**Atari Technical Bulletin**  
**Number: TT30-0002**  
**Date: February 28, 1992**  
**Page 1 of 3**

Product(s) Affected: TT030  
Model: TT030/2/4/8  
Type of ATB: As Needed  
ECO #: 1425

Addresses the "HDX" Format problem reported by the field with TT030's and some versions of TOS.

**Figure 1**

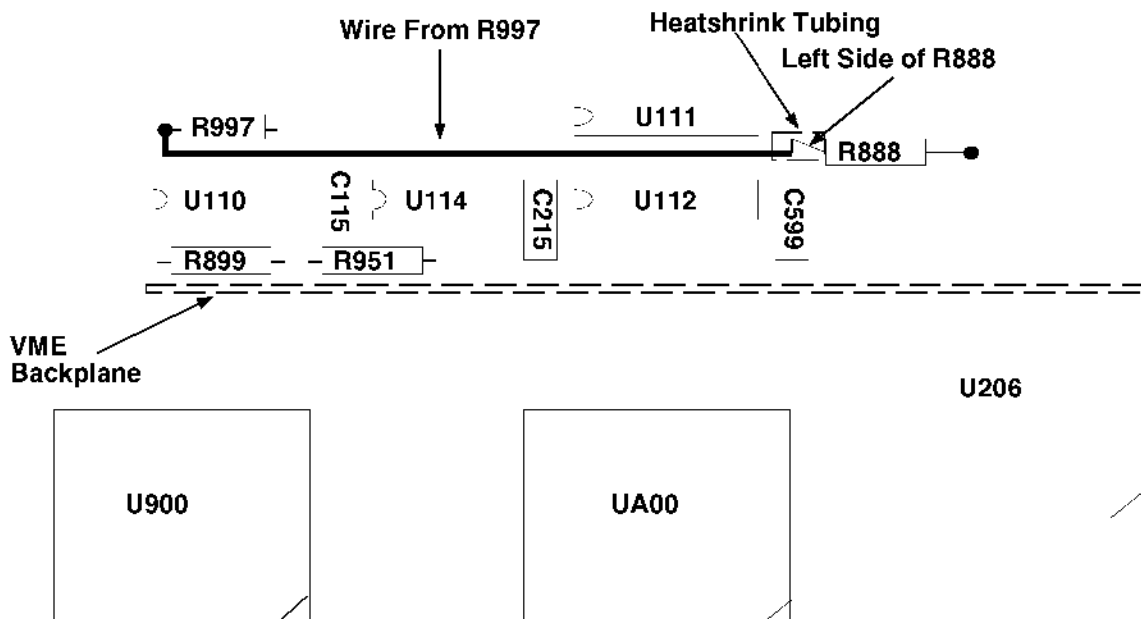
When trying to format the hard disk with the HDX utility, the system locks up and never finishes. This is a hard failure and occurs on every attempt.

1. Lift left side of R888 (side nearest U111).
2. Connect a jumper wire (as short as possible) from the left side of R997 to the left side of R888 (side nearest to U111). Insulate the connection at R888 with a piece of Heatshrink Tubing to prevent shorting to the solder pad under R888.
3. Test for the problem being corrected by rerunning the HDX program and reformat the hard disk.
4. Reassemble machine.
